Memorandum

ADDENDUM No. 3
ROSTER WORK ASSIGNMENT No.: 23-PFR-CAP-GC-008 ROSTER REOI
No.: 3907-19-5003

Eastville Training Centre – Electrical Upgrades

NEW MECHANICAL WORK PLAN

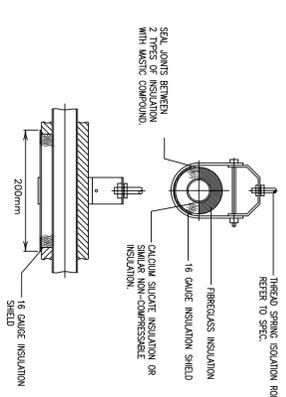
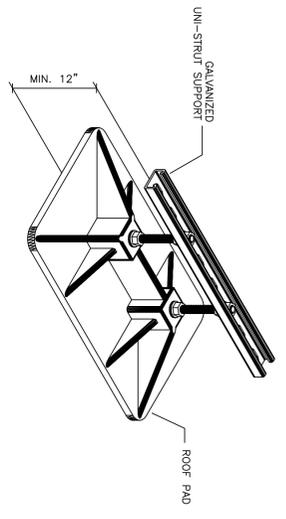
1. Provide price as listed in the revised pricing form for added mechanical scope of work as per attached Drawing M1 & M2.
2. Electrical Contractor shall provide power connection to outdoor condensing unit, CDU-1 c/w local disconnect switch. Feed from new 30A-2P breaker in Existing Panel P2 and wiring of 2#10 RW90+G in ¾" C. Provide power connections & wiring in ¾" c conduits to indoor AC Units and corresponding condensate pumps from outdoor condensing unit.
3. Revised pricing sheet:
